Village of Arlington Heights
Plan Commission
Board Room
Arlington Heights Village Hall
33 S. Arlington Heights Road
Arlington Heights, IL 60005
September 27, 2017
7:30 PM

- A. CA Ventures/Sigwalt Apartments-45 S. Chestnut Ave.- PC#17-008
PUD, Preliminary & Final Plat of Subdivision, Re-zoning,
Variations

Item: CA Ventures/Sigwalt Apartments - 45 S. Chestnut Ave.- PC#17-008

To: Plan Commission

KLOA
Kenig, Lindgren, O'Hara, Aboona, Inc.
Job No: 17-127 Figure: 5

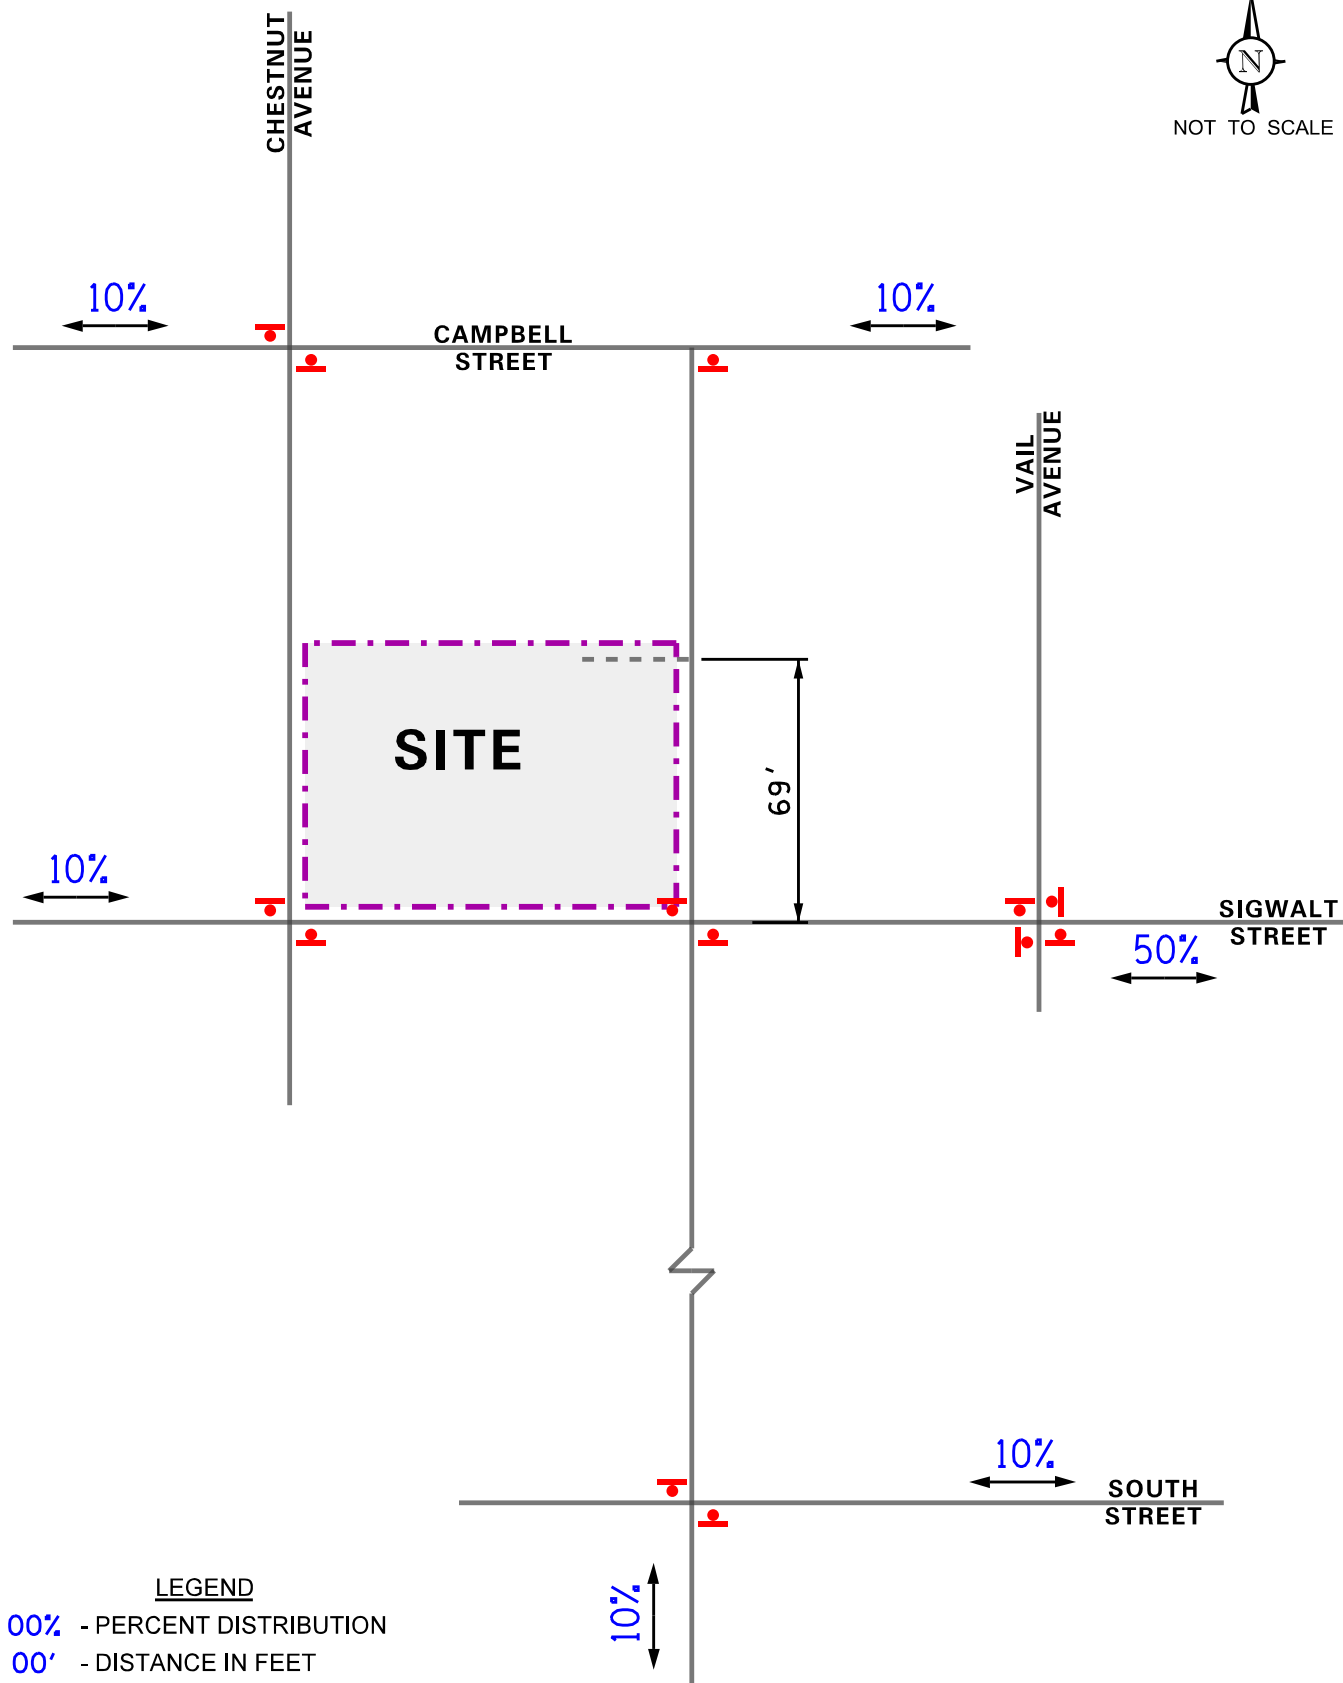
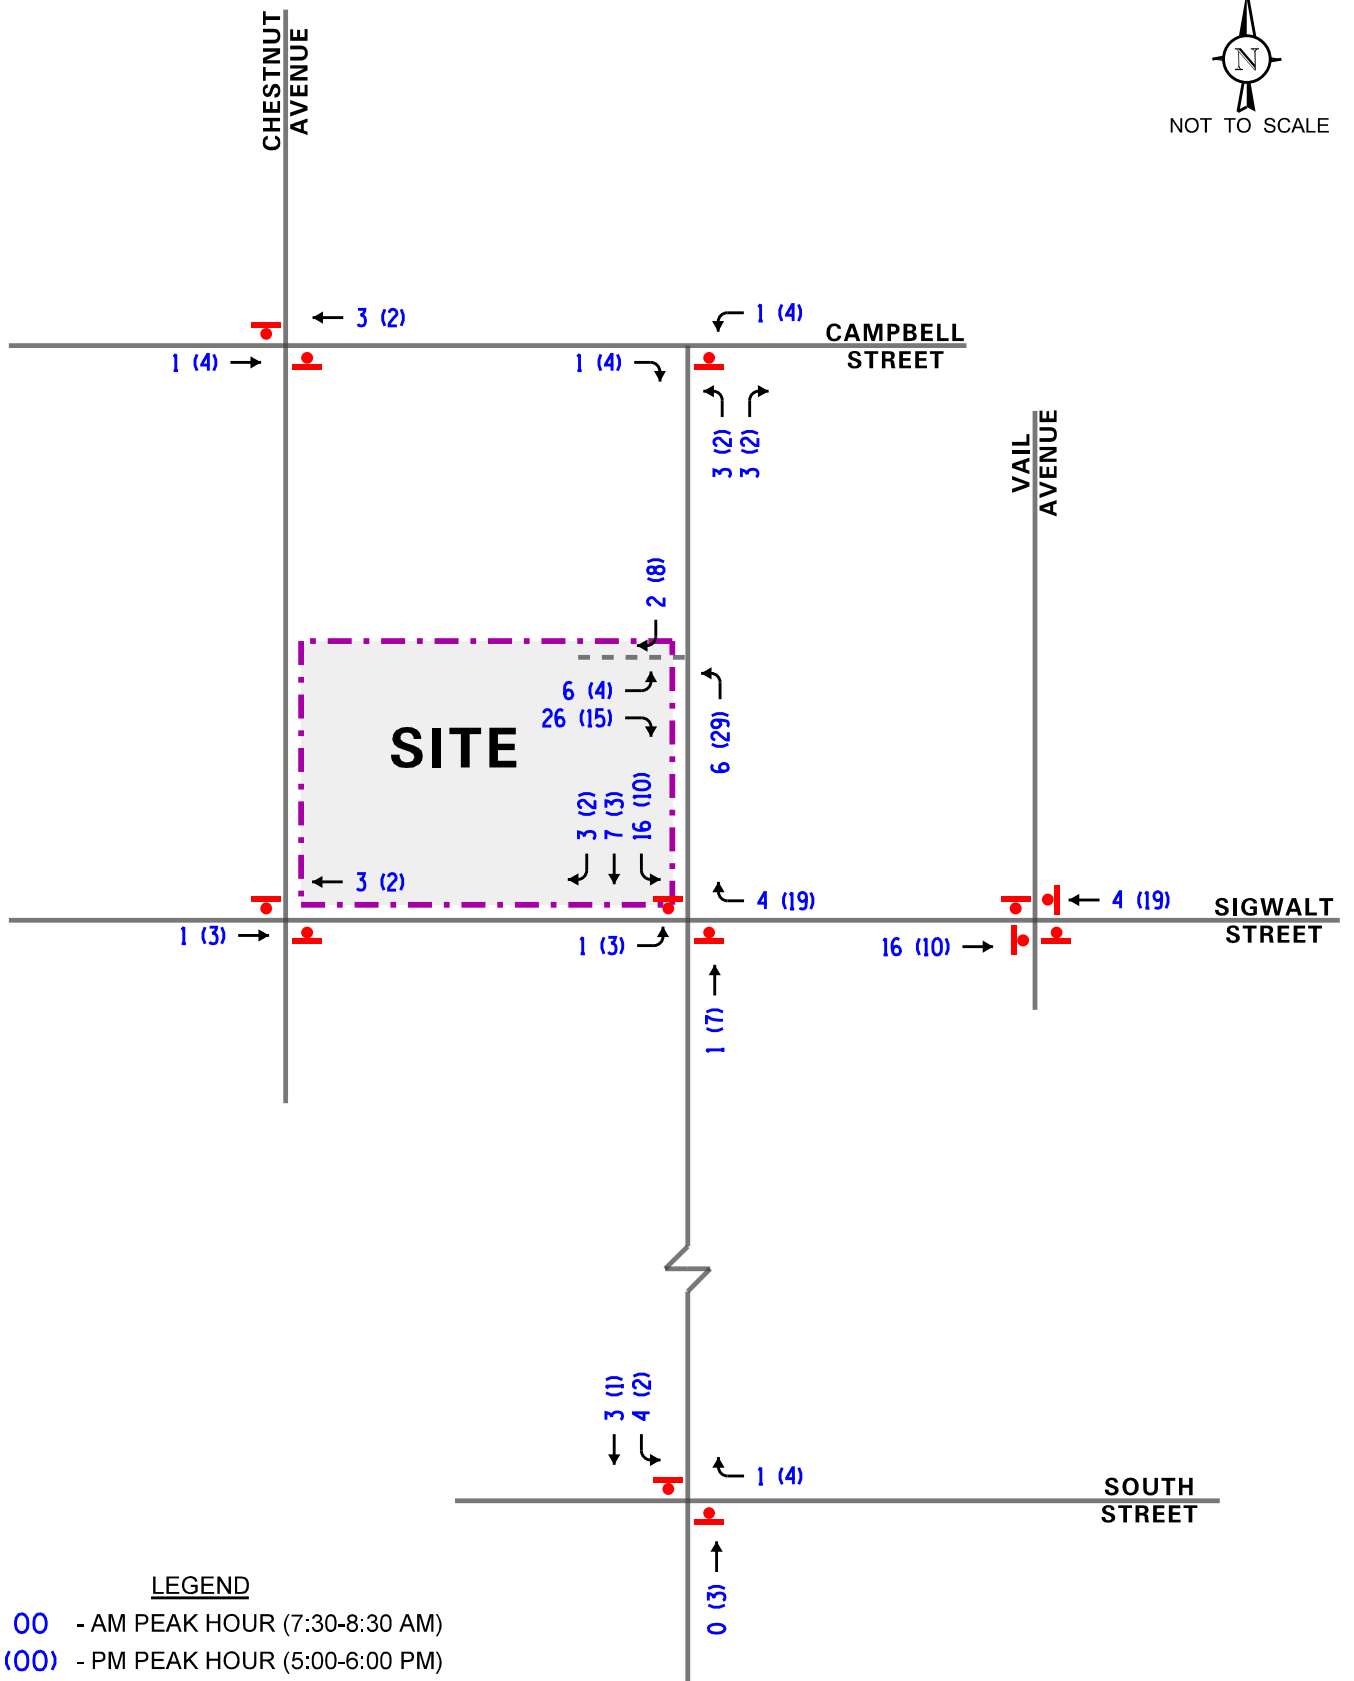
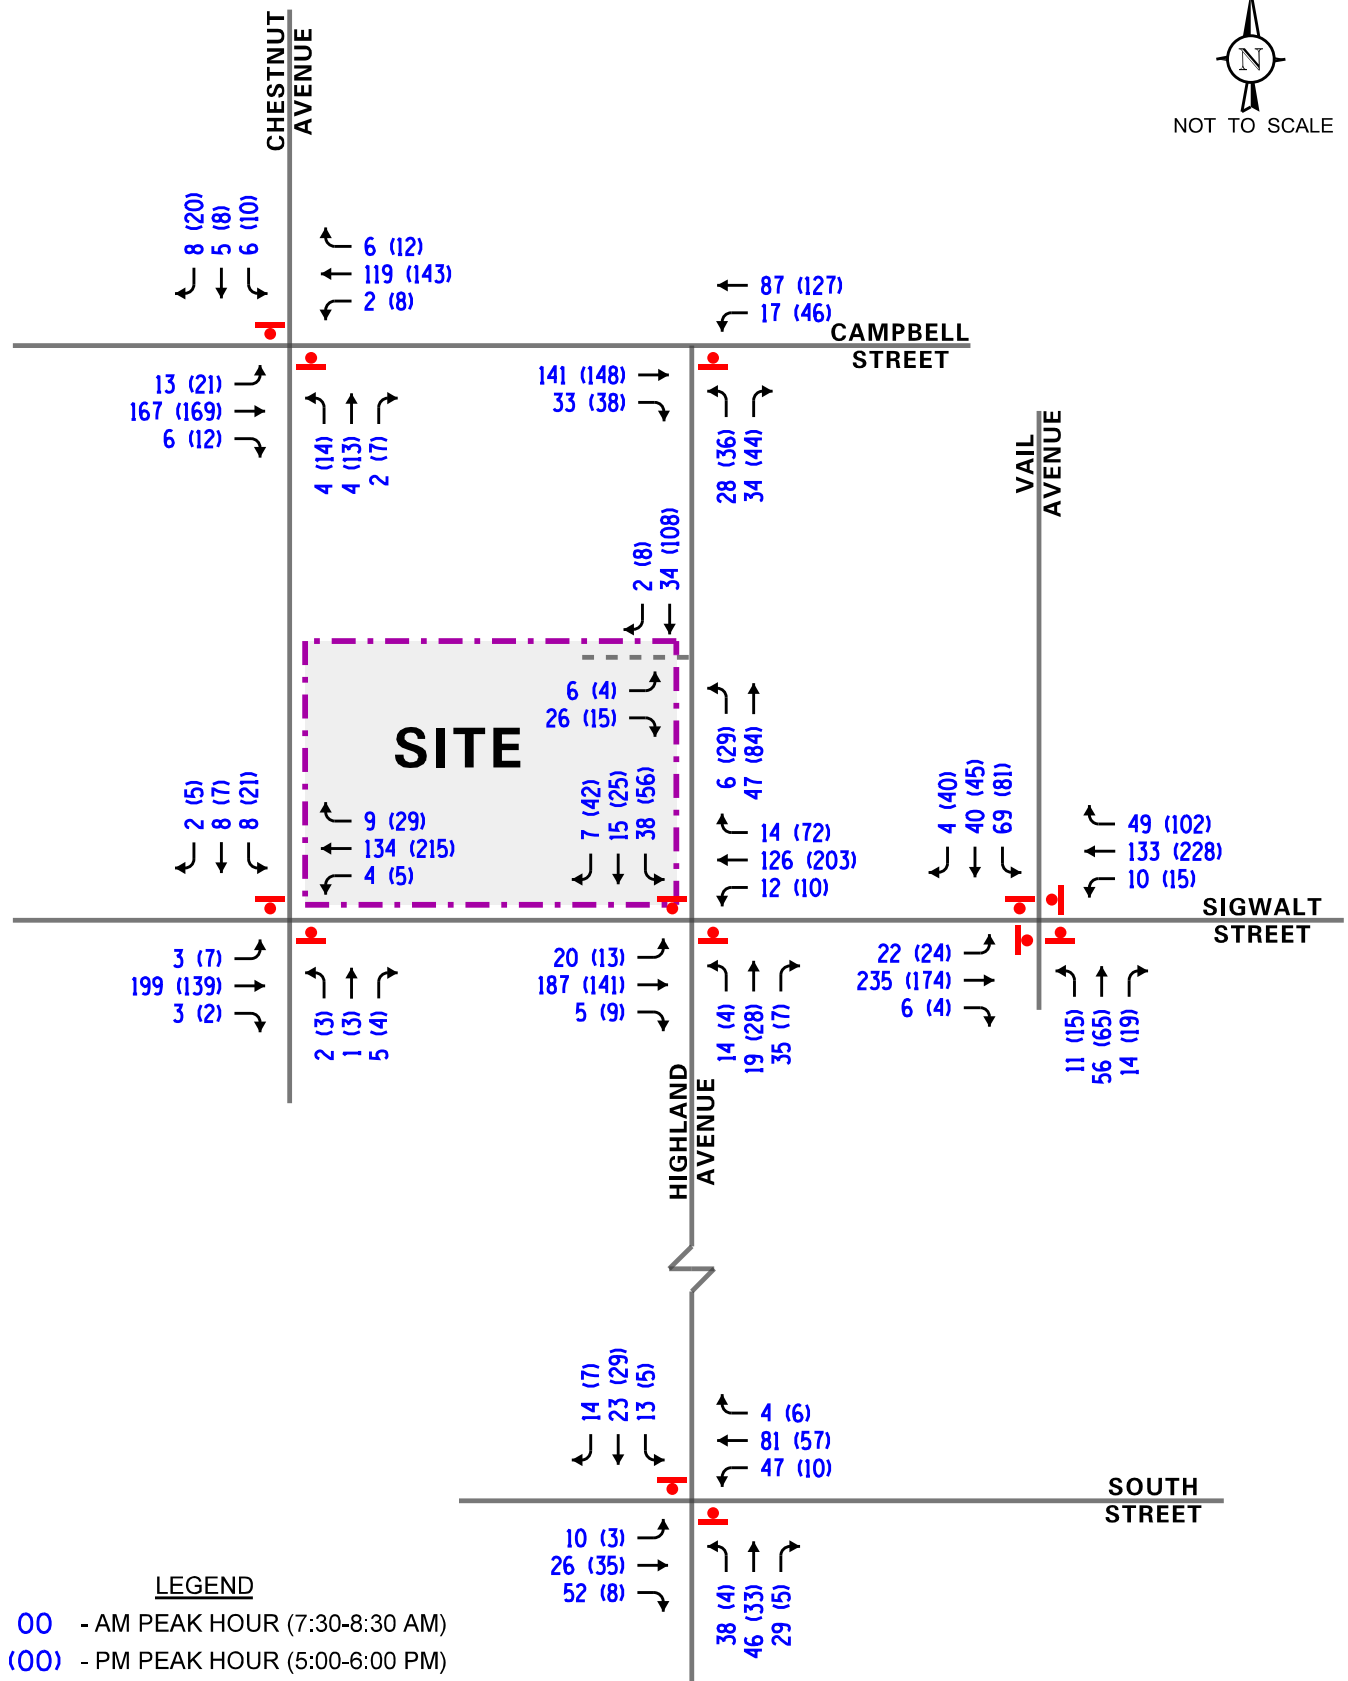
- 22. The representation of site traffic distribution seems incorrect as only 10% of site traffic is proposed from the north. The Traffic data reflected in Figures 4, 5, 6, and 7 should be modified to show the peak hour traffic counts for the intersections of Campbell and Chestnut.**

29. The response made by the petitioner to comment #22 is not acceptable. Although the site generated traffic has included the additional intersections requested, the values shown on Figure 6 do not sum correctly through the intersection of Sigwalt and Highland for the site generated traffic.
